# ESIA Review

## Independent 3<sup>rd</sup> Party Assessment of the Impacts on Water Resources and Geology, Biodiversity and Air Quality

## Amulsar Gold Mine The Republic of Armenia

Investigative Committee of the Republic of Armenia

**Figure 2.1.2: Flow Chart - Water management during closure phase (Figure 6.10.3 of the ESIA)**

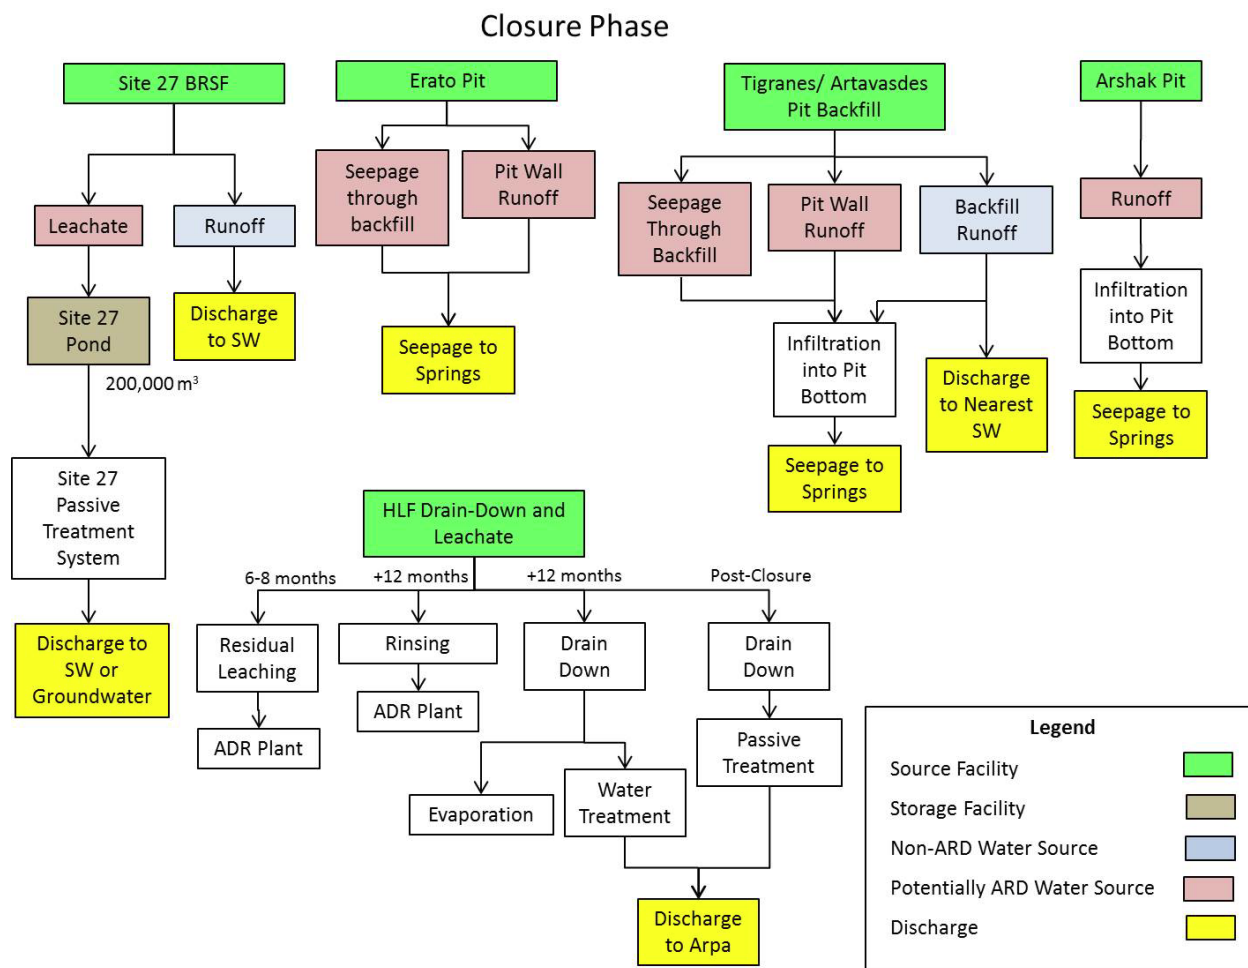
A flow chart of the water management during the closure phase presented as Figure 6.10.3 in Chapter 6.10 of the ESIA is shown below as Figure 2.1.2. The water from the residual leaching and rinsing are shown going to the ADR plant, and then inexplicably disappearing. GRE (2014d; page 71) gives an estimate of 2 million m<sup>3</sup> of water in the HLF after rinsing. The water by this time has been in circulation for ten years and will have elevated levels of sodium, chloride, sulfate, nitrate and probably other ions as well. Assuming the volume of HL solution is in the same range as that remaining in the HLF after rinsing (*i.e.*, >1,000,000 m<sup>3</sup>), the management and disposition of such large volume of contaminated water should be addressed.

The ESIA proposes a dedicated PTS to be designed and implemented upon closure based on post-closure water quality monitoring and present generalized descriptions of processes for treating the leachate from the HLF post closure. This may be a reasonable approach; however, the ESIA should include plans for laboratory treatability and pilot testing to evaluate and confirm the feasibility and effectiveness of the PTS in treating the HLS and leachate and in achieving the discharge criteria. Furthermore, there are no contingency plans in case of the PTS failure to effectively treat the HLF wastewater or in future cases of PTS failure or emergency.

Figure 4.10.6: Small boulder with 50 plants of *P.porphyrantha*

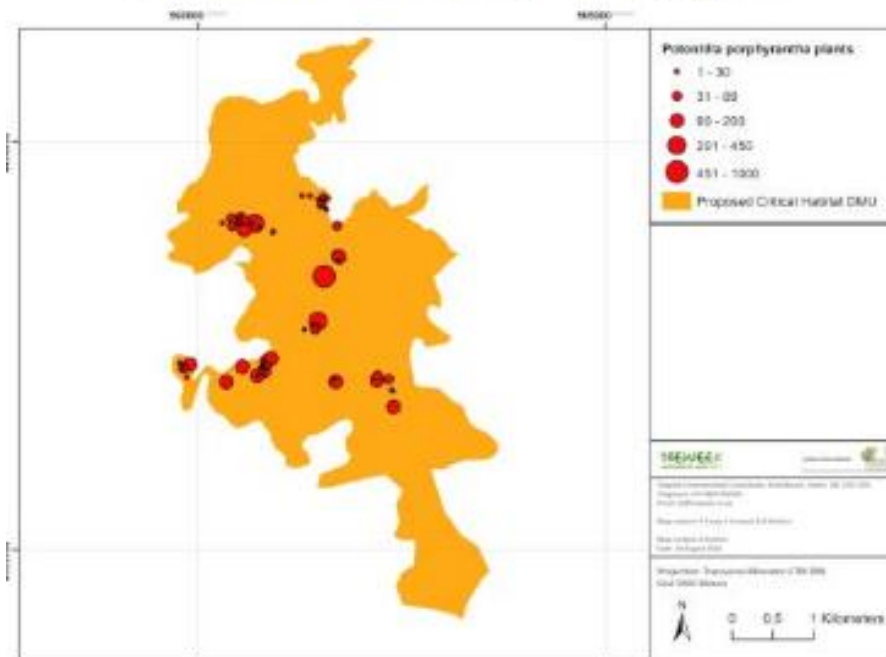
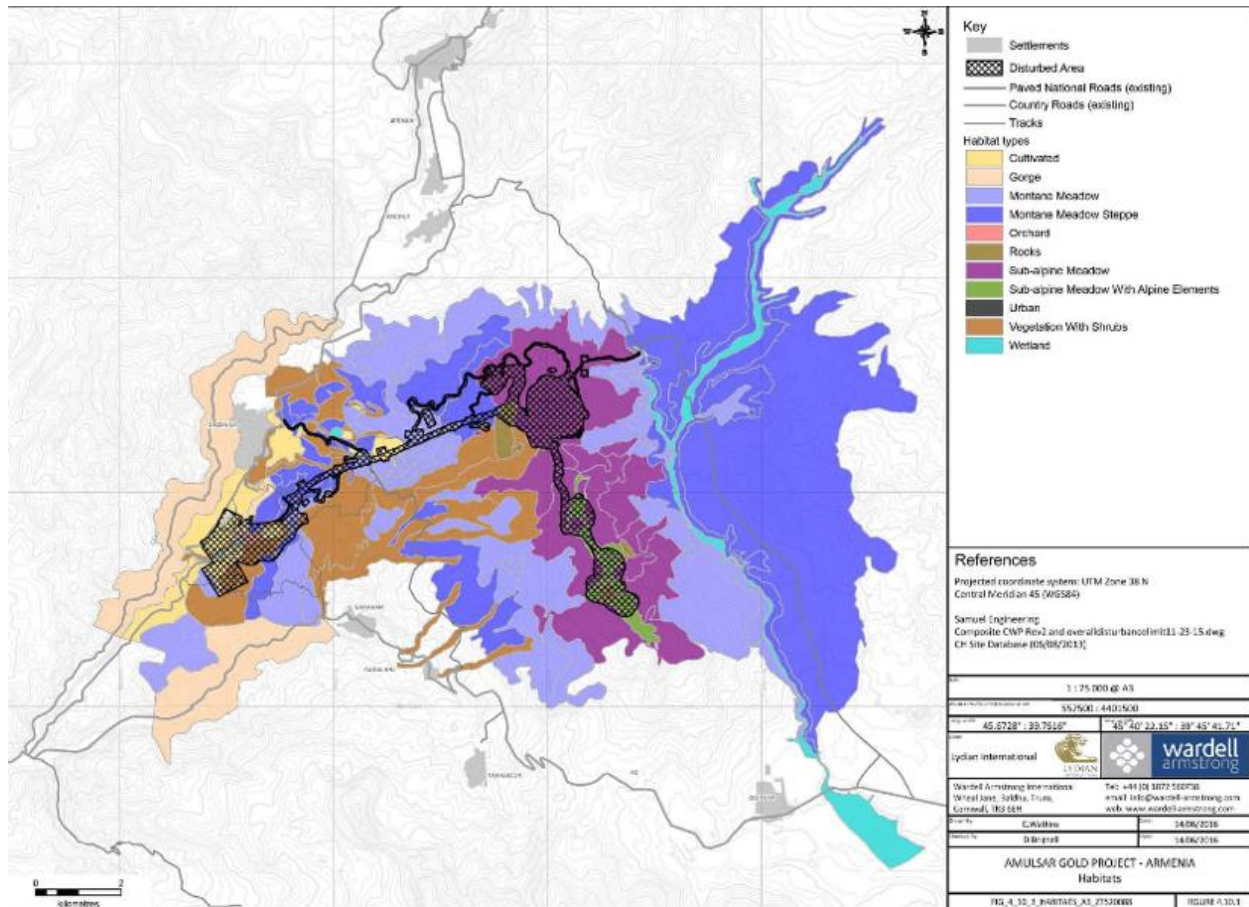
The distribution map of *Potentilla porphyrantha* (sampled points) is provided without description or mapping of the critical habitats for this species identified as “subalpine meadow with alpine elements” (in green in the below map) in which the species occurs on suitable rock substrate (see photo).

As per the map, the habitat will be heavily impacted by the project. The report states

“The physical footprint of the project on this species is estimated to be on 150.5 hectares (12.5% of the total area of critical habitat)”.

This assumes that the species occupies the entire area of critical habitat (1200 hectares) when it occurs only on a subset of the area where suitable habitat occurs. Therefore, 12.5% is an underestimate of the area occupied by this species.

Effort to count of all individuals; a precise map of species habitat would have significantly improved the estimate of project physical footprint and potential mitigation.
